CITY OF WALTHAM, MASSACHUSETTS  
WINTER STREET WATER MAIN  
LINING AND REPLACEMENT PROJECT

<b>PROPOSED WATER MAIN LINING</b>	
<b>WINTER STREET STA 33+25 TO 43+75</b>	
CITY OF WALTHAM, MASSACHUSETTS	
WINTER STREET WATER MAIN	
LINING AND REPLACEMENT PROJECT	
<b>GCG ASSOCIATES, INC.</b>	
WILMINGTON MASSACHUSETTS	
SCALE: 1" = 20'	DATE: DECEMBER 12, 2022
JOB NO. \ FILE NAME:	DESIGNED BY: K.M.C.
21102 - BID SET	DRAWN BY: L.P.B.
	CHECKED BY: M.J.C.
	PLAN NO.
	8 OF 30

Notes added by City of Waltham  
Engineering Department 9/21/2023 For  
Addendum #4

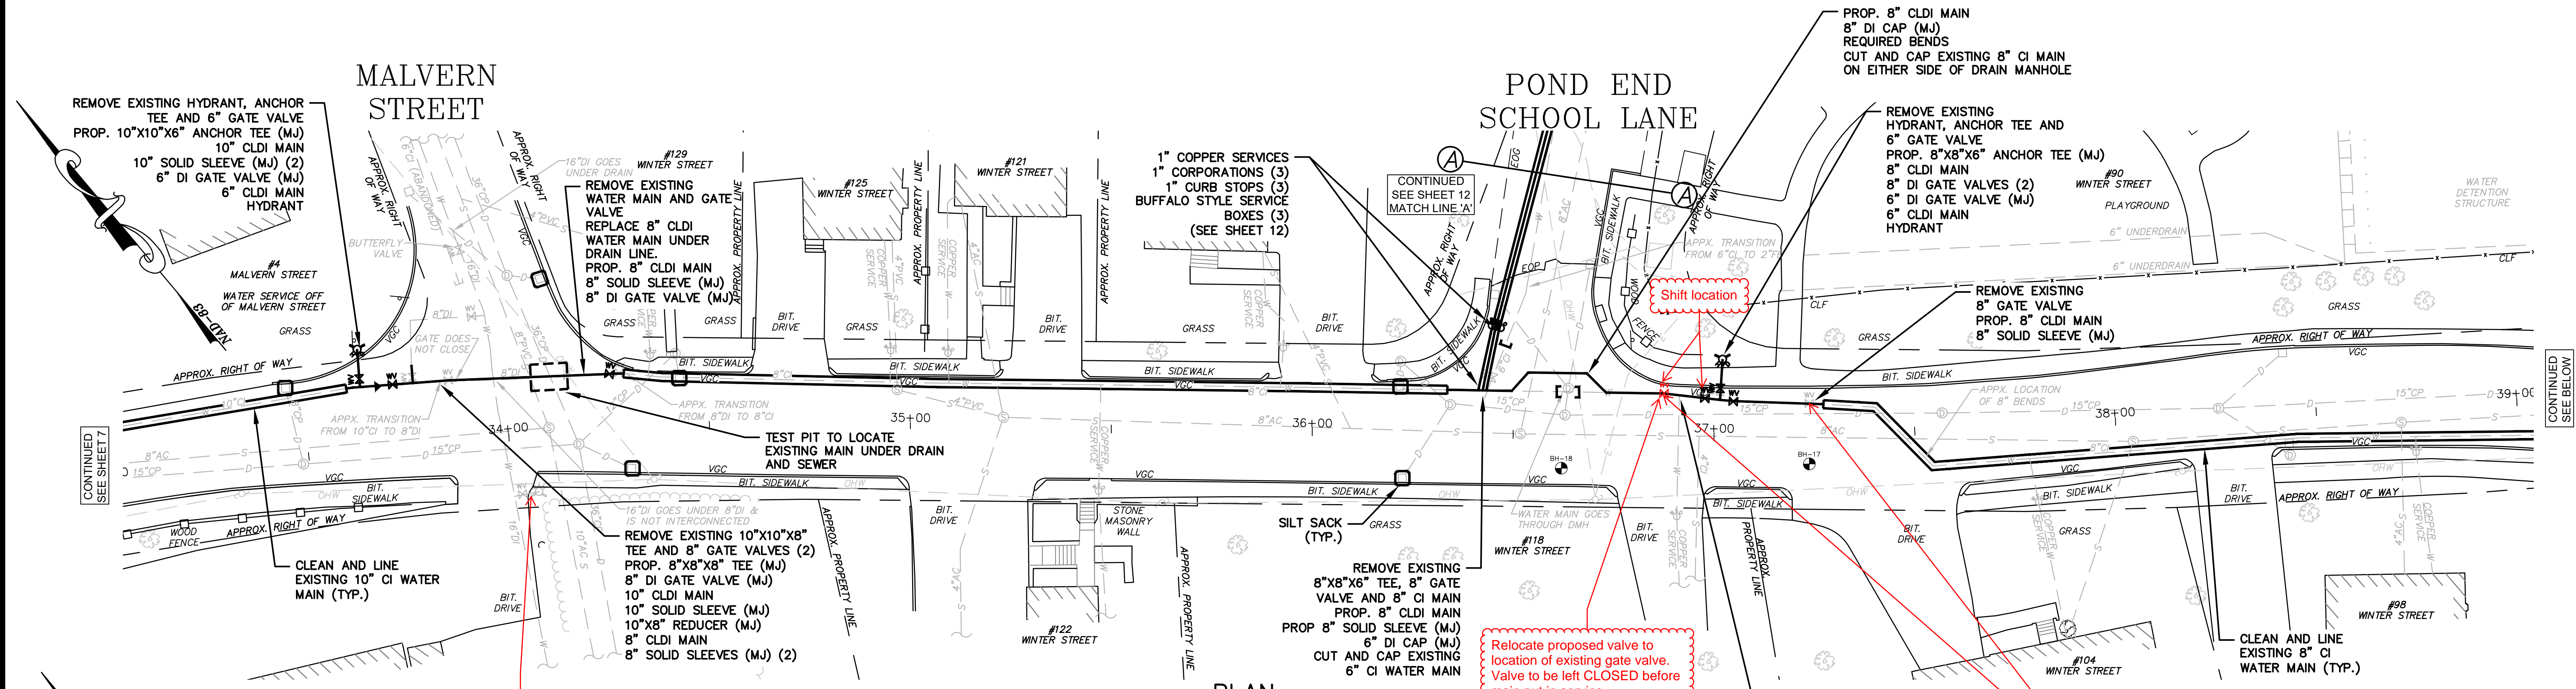
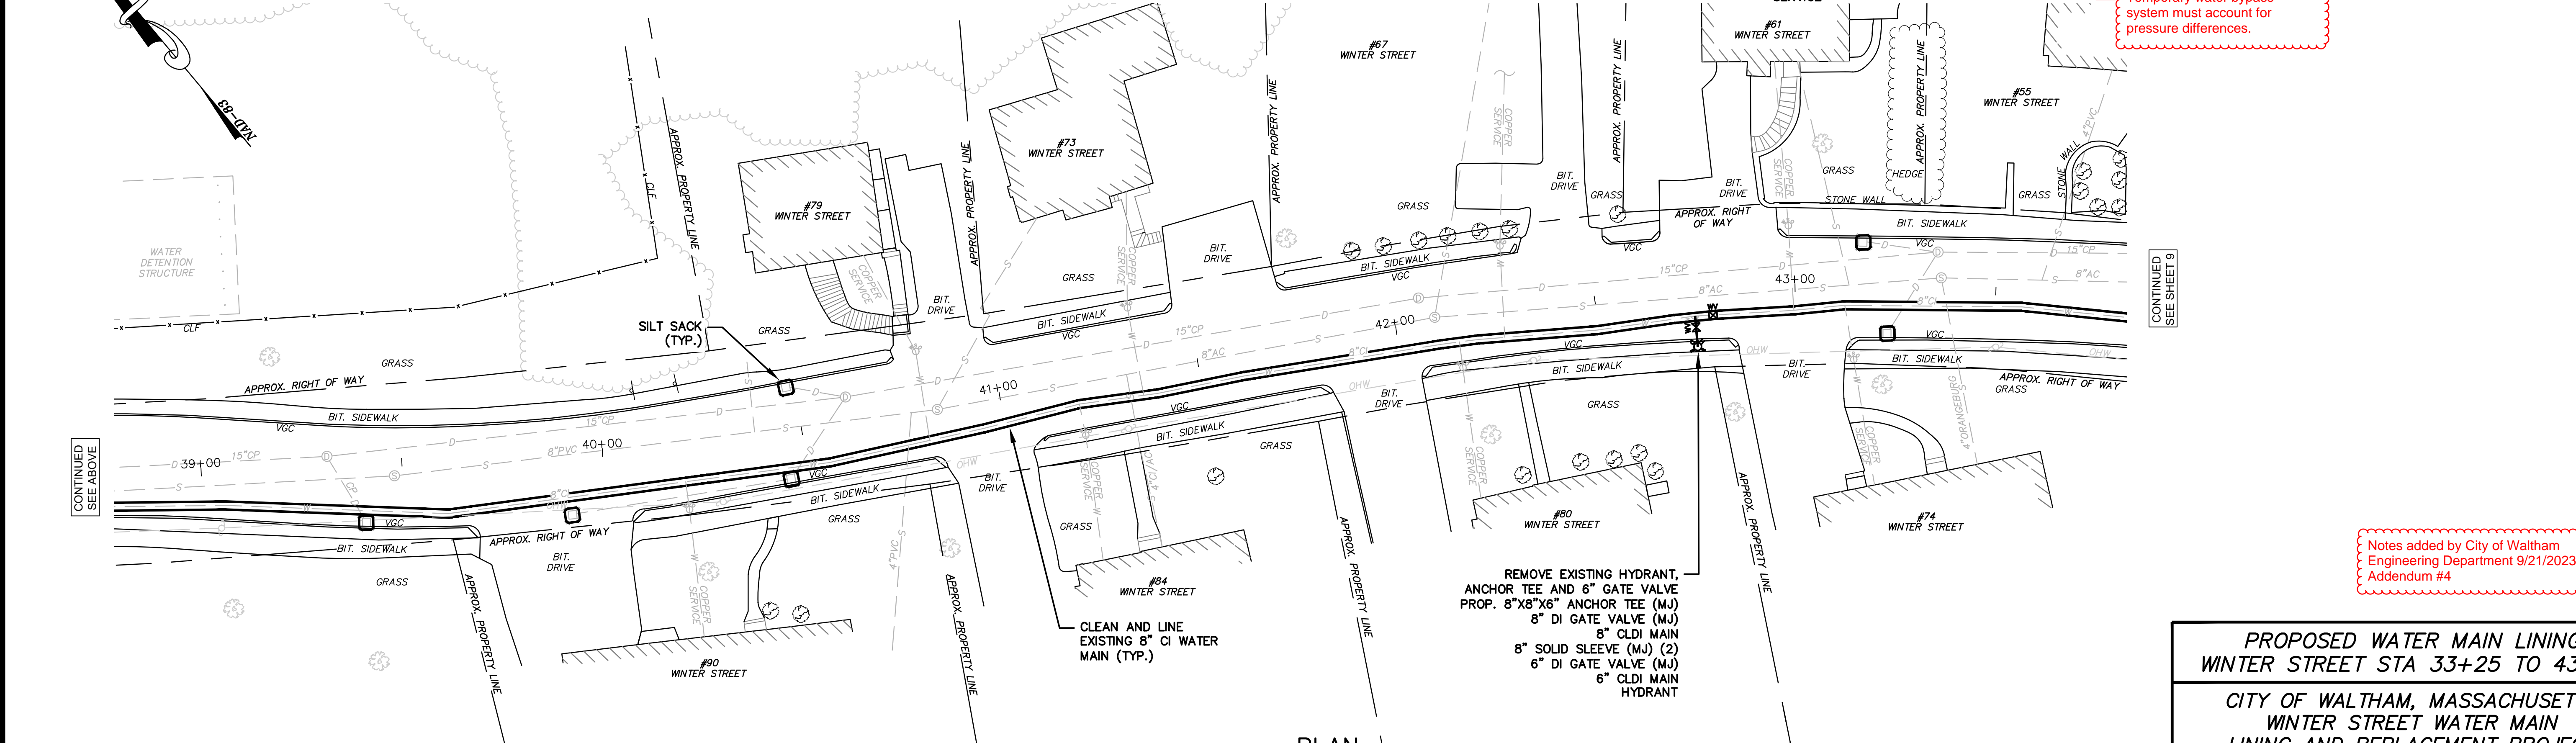
Existing hydrant off 16" main  
may be used for bypass feed.

Relocate proposed valve to  
location of existing gate valve.  
Valve to be left CLOSED before  
main put in service.

These existing valves separate  
two pressure zone systems.  
Temporary water bypass  
system must account for  
pressure differences.
